Sizewell C (SZC)

Planning Inspectorate Reference: *EN010012*

Deadline 7 – 3 September 2021

East Suffolk Council comments on Deadline 6 submissions from the Applicant

Figure 2: Campsea Ashe, pen superimposed on Google Maps imagery.

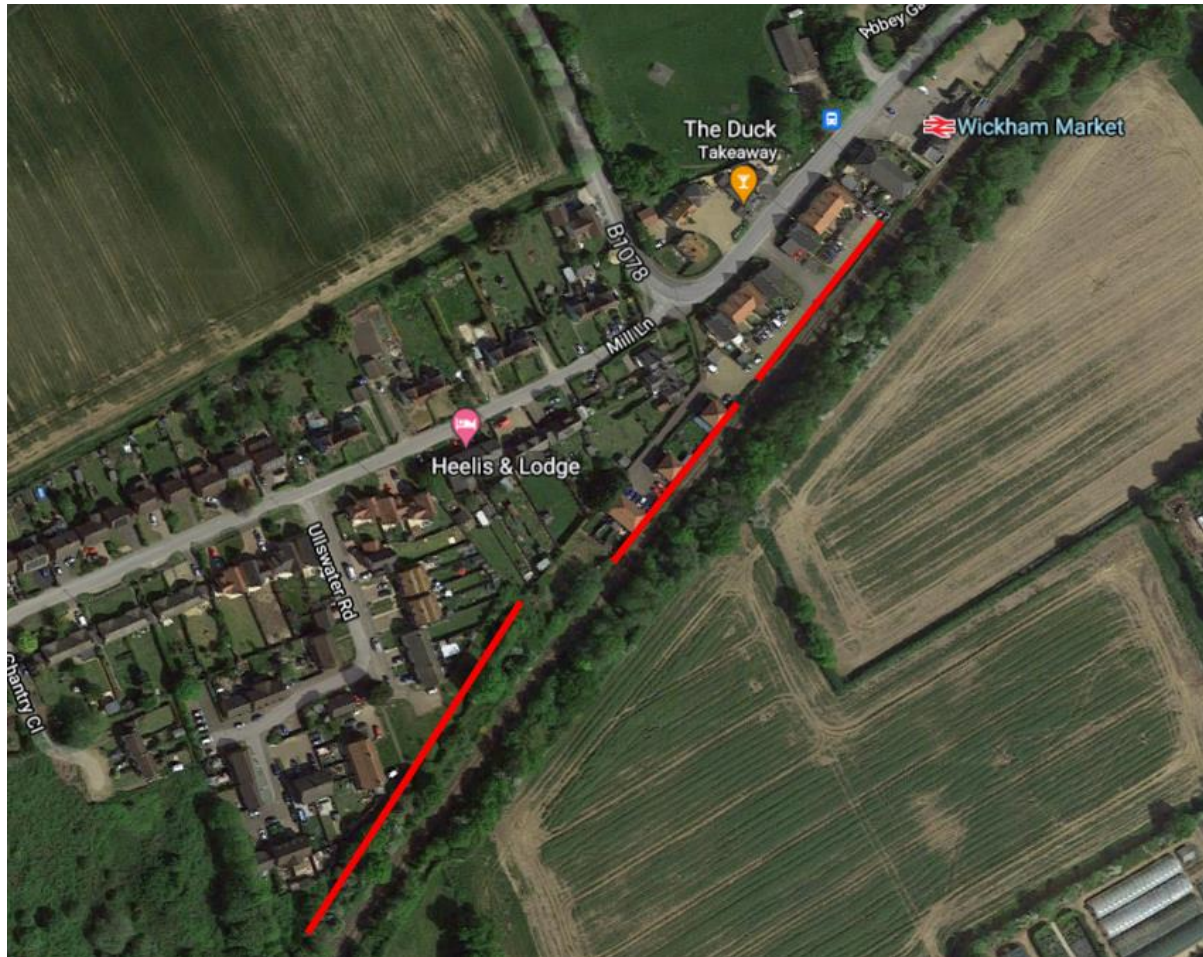
For ease of reference, ESC has separated the railway line through Campsea Ashe into three sections, as shown on Figure 2 below.

Top red line:

Dwellings along Little Horsea Park, opposite The Duck public house (the top red line as indicated above), are set back slightly from the railway line and so have a reasonable amount of separation and planting between them and the railway line, creating the perception of some separation. If the vegetation is retained and the fencing could be installed somewhere between the vegetation and the railway line, then ESC could consider this acceptable. However, if the acoustic fencing was required to stand on the rear boundary of those dwellings, so the rear garden boundary of those properties had to be a 4.5m fence, then it would be oppressive and an overbearing form of development.

Middle red line:

Further down the railway line to the south there are five dwellings standing very near the railway line where fencing would likely have a significant adverse amenity impact as there is a very small amount of land separating the dwellings from the railway line. These dwellings are numbers 16-20 on the private road off Hembling Terrace (planning application reference C/10/2510).

These dwellings are south-facing and so a 4-4.5m acoustic fence would block a significant amount of sunlight/daylight, and so the amenity impact would be larger and may significantly limit the occupants' enjoyment of their private amenity space. Therefore, on balance, ESC's support for acoustic fencing in this location is dependent on where the fencing would be erected, and on where the planting sits in relation to Network Rail land.

Bottom red line:

Further south on the railway line ESC considers acoustic fencing would have a less significant amenity impact based on the positioning of dwellings. Numbers 1-6, 9, and 10 Ullswater Road (created by demolishing 8 dwellings and replacing with 20 dwellings, reference C/09/1862) are set back slightly from the railway line and separated from it by trees and vegetation. ESC considers there is potential scope for acoustic fencing along this stretch of railway line, though would require further information in terms of positioning and retention of vegetation/planting.
